STAFF REPORT
Proposed Veranda Master Plan and Subdivision

FILE NUMBER: SD/MIS 20-26000343 (MPLAN 21- 00652)

PROPOSAL: To establish an applicant-initiated Pleasant Valley Master Plan and 187-lot subdivision (revised to 175 lots) for an approximately 38.9-acre area. All existing improvements on the site will be removed and the current well and onsite septic system will be decommissioned.

RECOMMENDATION: Staff recommends denial of the proposed applicant-initiated Pleasant Valley Veranda Master Plan and the 175-lot subdivision.

Figure X: Wetlands

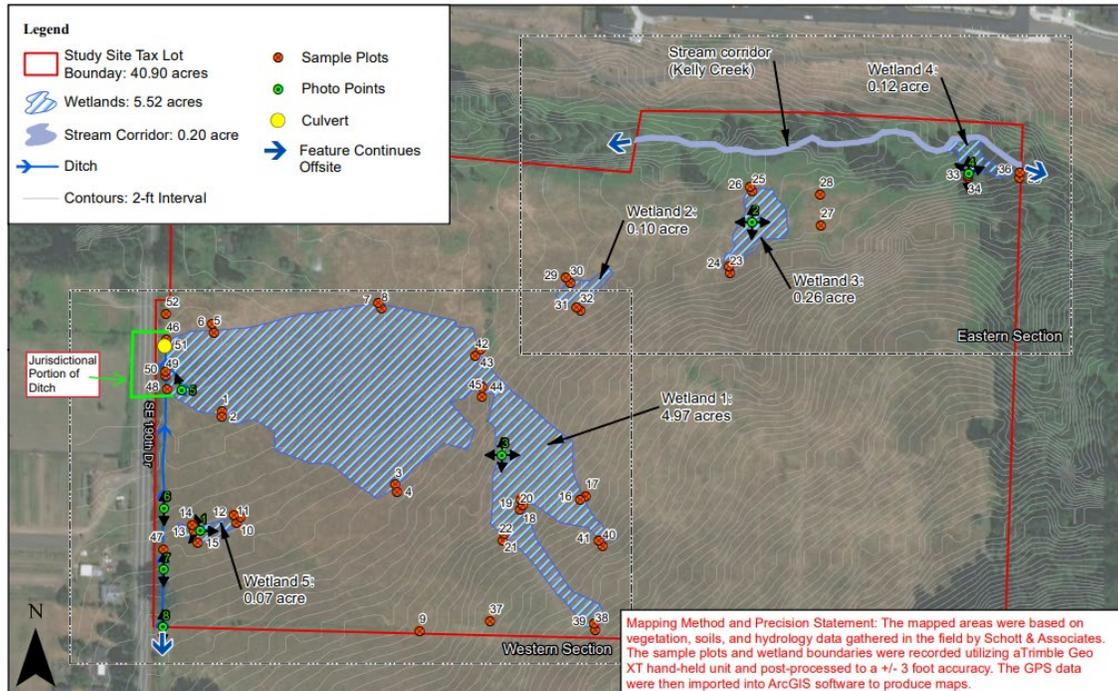
Wetlands have been delineated on the site as shown in the applicant’s provided January 2020 DSL wetland concurrence (Exhibit C), including a 0.12 acre wetland immediately along Kelley Creek to the northeast, a 0.26 and a 0.1-acre wetland to the north, a larger

4.97-acre wetland on the western half of the property, and a smaller 0.07 wetland nearer the southwest corner for a total of 5.4 acres. This delineation was documented and received concurrence from DSL prior to submittal of the subject application.

The City determines the wetlands delineated in Exhibit B-4 to be locally significant and thereby subject to the provisions of the ESRA-PV as described under this section. The wetlands are observed to have a hydrologic connection to Kelley Creek, a 303(d) listed resource, to provide a cooling impact on the creek and larger watershed system.

The applicant has not provided documentation that the wetland does not provide benefit or is not hydrologically connected with Kelley Creek.
